# CITY PLANNING COMMISSION

- APPLICATION:
1. Environmental Determination
  2. Special Permit for condominium development in the R-2B(PUD) zone (Sec. 2-B-3a, Zoning Ord.)
  3. Tentative Map (P83-387)

PROPOSAL: The applicant is requesting the entitlements necessary to develop 168 condominium lots to be known as Baywood Condominiums.

PROPOSAL: The applicant is requesting the necessary entitlement to alter exterior building materials and stairway orientation for Baywood Condominiums.

LEFT ELEVATION  
1/2" = 1'-0"

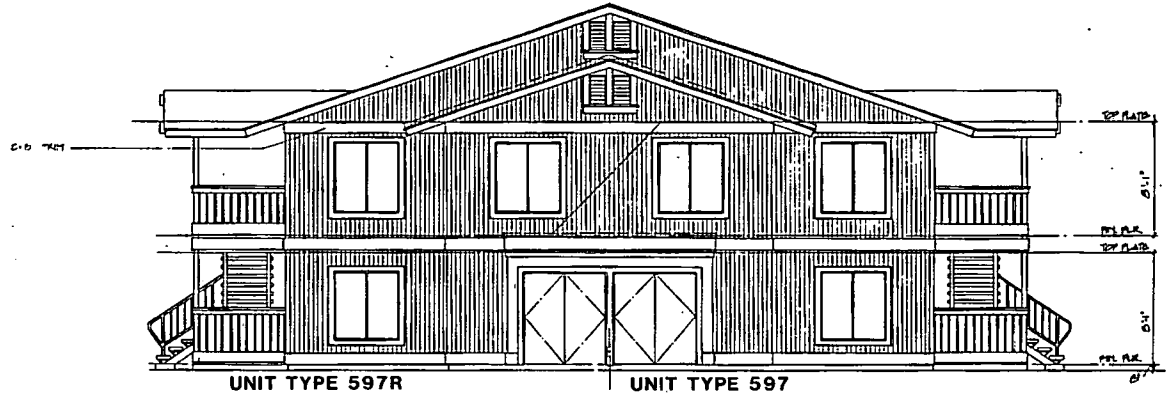
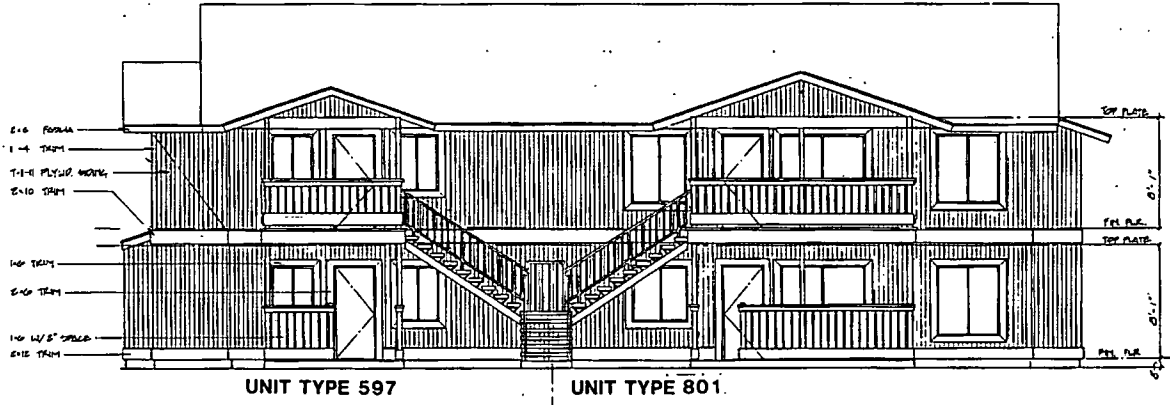
- C. The applicant now proposes T1-11 plywood siding with precast concrete stairs and metal handrails. Individual staircases descend to a common landing which extends out perpendicular to the structure's facade. Windows are standard metal frame sliders. The similarity to Craftsman architecture is eliminated. This also eliminates the unique character of the units causing a typical apartment atmosphere. In addition, the T1-11 siding presents problems in long range maintenance which would be of concern to individual owners.

- A. Ratification of the Negative Declaration;
- B. Denial of the Modification of a Special Permit, based upon the following Findings of Fact:
  - 1. The project is not based upon sound principles of land use, in that:
    - the modifications create a typical apartment appearance and eliminates the unique architectural characteristics that lend themselves to individual ownership units.
  - 2. T1-11 siding is more difficult to maintain over a period of time.

**APPROVED PLAN  
ELEVATIONS**

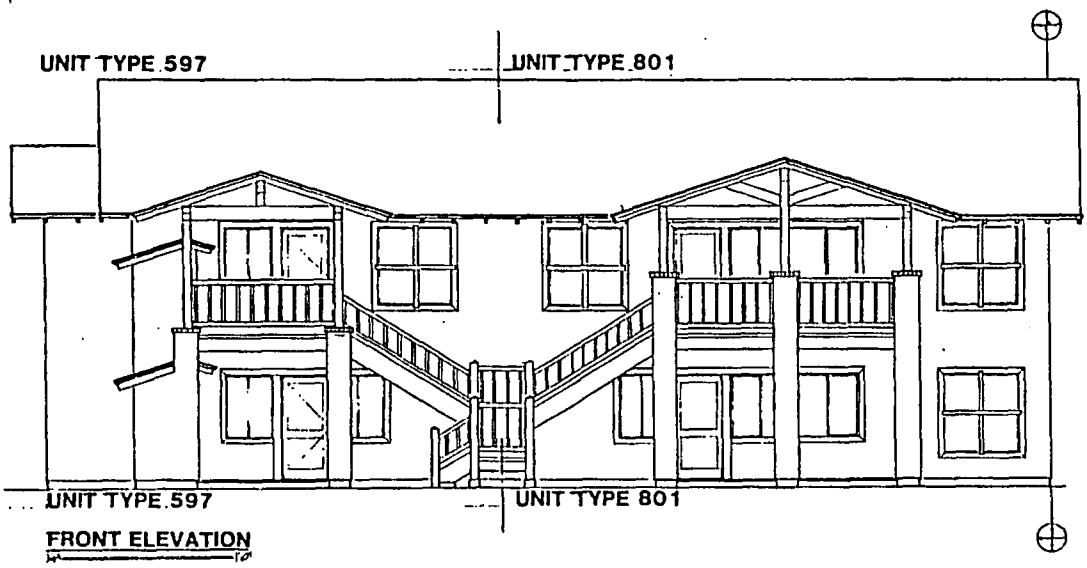
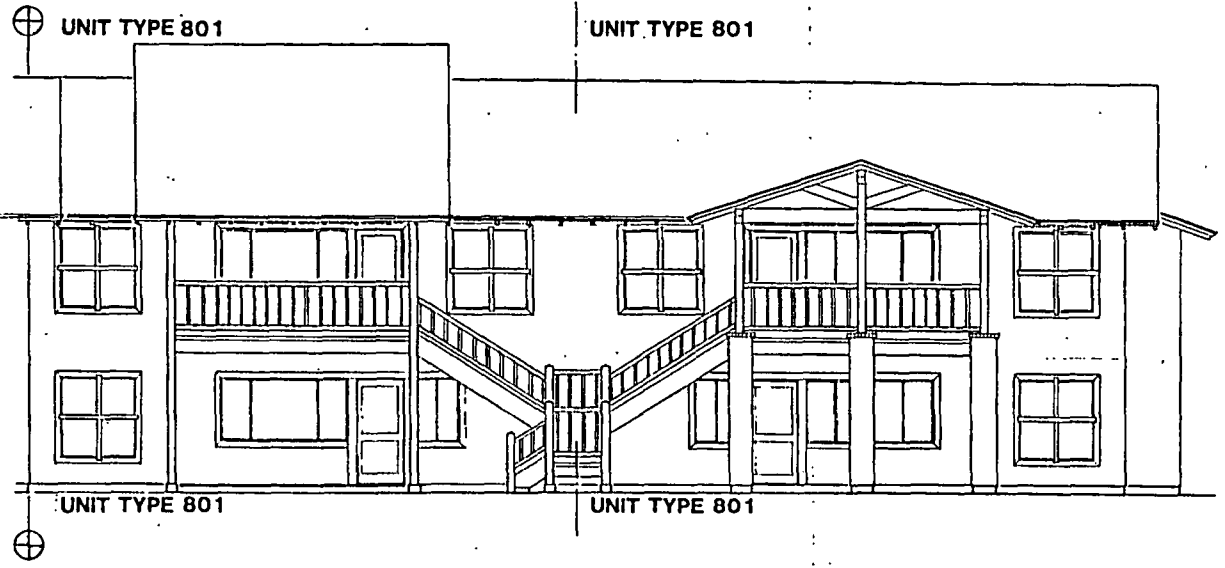
- B. The previous plans indicated stucco exteriors with wood trim. Stairways were to be of wood. Individual two second story staircases descended to a common landing and then continued on in one direction to the ground. Windows were to be single or double-hung and wood trimmed. The resemblance to the Craftsman style of architecture provided character and design interest. The unique design lent itself to support of the individual ownership of units (see Exhibit A).
